MM912F634, Silicon Analog Mask (M91W) / Digital Mask (M33G) Errata

This mask set errata applies to the Analog mask M91W for these products:

Document Number: MM912F634ER
Rev. 8.0
6/2015

Figure 1. Low-side Block Diagram

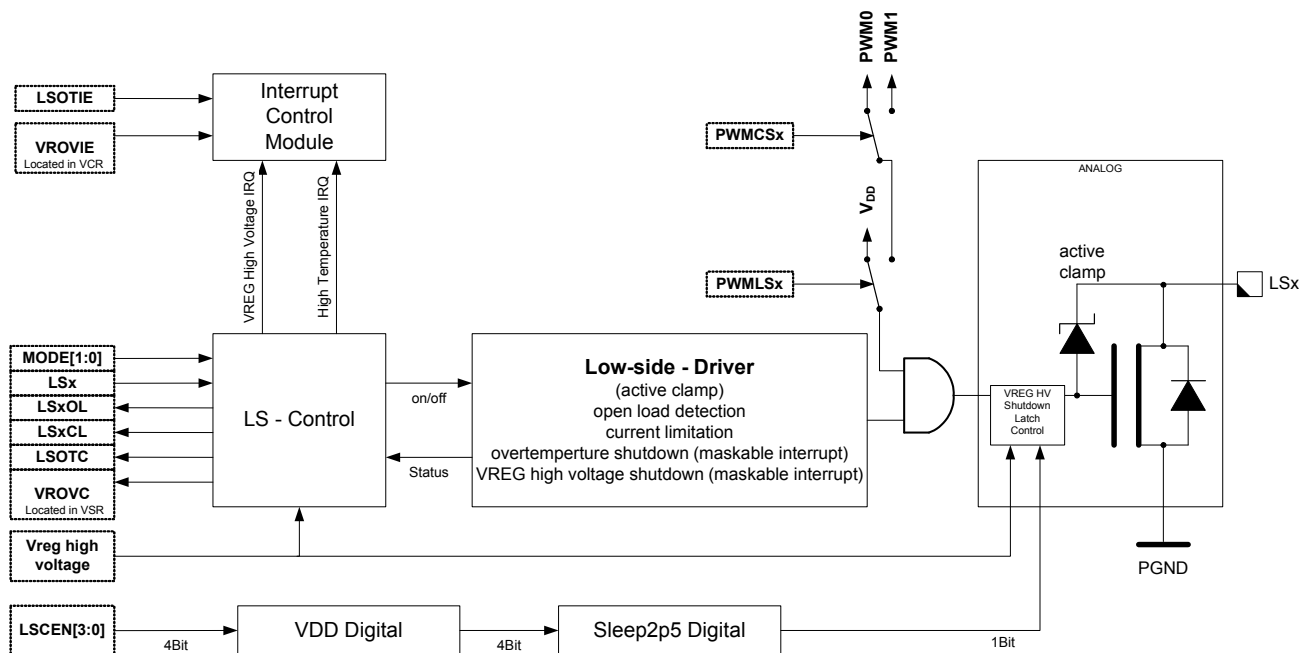
The Low-side Control Enable (LSCEN) register is reset only after LVR, LVRX and POR. It is also supposed to reset in case of an VREG Over-voltage event. See [Figure 1](#).

A digital implementation issue prevents the LSCEN register from resetting in case of a VREG high voltage condition. This register was implemented to create a secondary deactivation stage for the Low-side drives, verifying the VDD-Digital and the Sleep2p5 Digital circuitry is functional after a VREG high voltage.

The Shutdown of the LS drivers is still established via the VREG OVERVOLTAGE FLAG and has to be acknowledged by the Software (IRQ optional).

The basic intention of the feature is still present as a functional VDD-Digital and the Sleep2p5 Digital circuitry is still required for the LS to be active. Other than specified, the register will not reset in case of a high-voltage condition and therefore would not need to be written to reactivate the Low-side drivers.

This feature is listed for correction in case of future mask corrections. It is recommended to maintain the register write LSCEN=0x5 to re-enable the Low-side drivers to assure software compatibility with the potential silicon fix.

Figure 2. Stop mode to Normal mode Transition

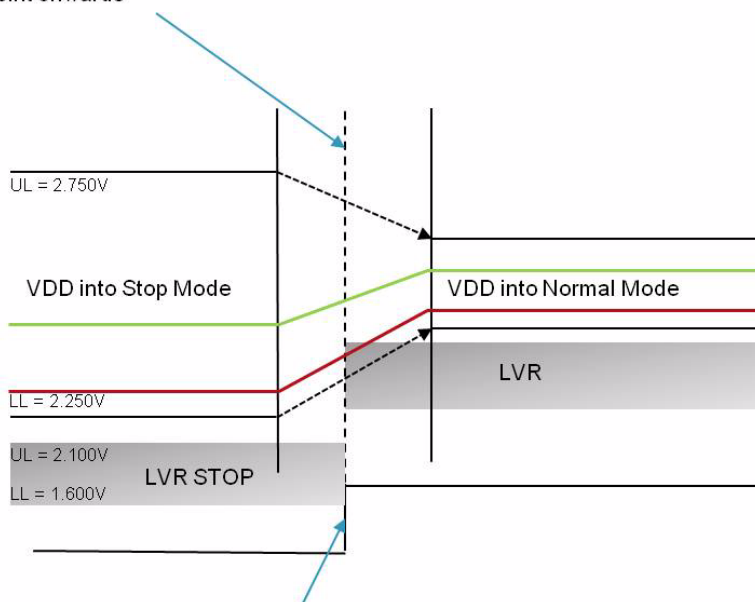
When a wake-up event occurs, the transition from stop mode to normal mode is started. The VDD stop regulator is switched to VDD normal regulator. The LVR normal mode is activated. In case the actual VDD regulator output voltage is below LVR normal, the device will generate a reset on RESETA pin.

When an LVR condition on VDD occurs during a transition from Low Power to Normal, a RESET is performed and WUR bit is set into RSR register. This is the standard behavior during wake-up from sleep mode.

NOTE: The green line denotes a part that does not show this behavior. The red lines denotes a part that does show this behavior. The VDD parameter in Stop mode is distributed between 2.25 V and 2.75 V, while the LVR Normal is max 2.40 V. Only devices that have an actual VDD stop between 2.25 V and 2.40 V will exhibit this behavior.

The software recommendation to help minimize impact of the behavior consists in verification of the reset source after a wake-up.

This check might be performed after return from reset sequence. In case a reset has occurred, the following flag will be as described below:
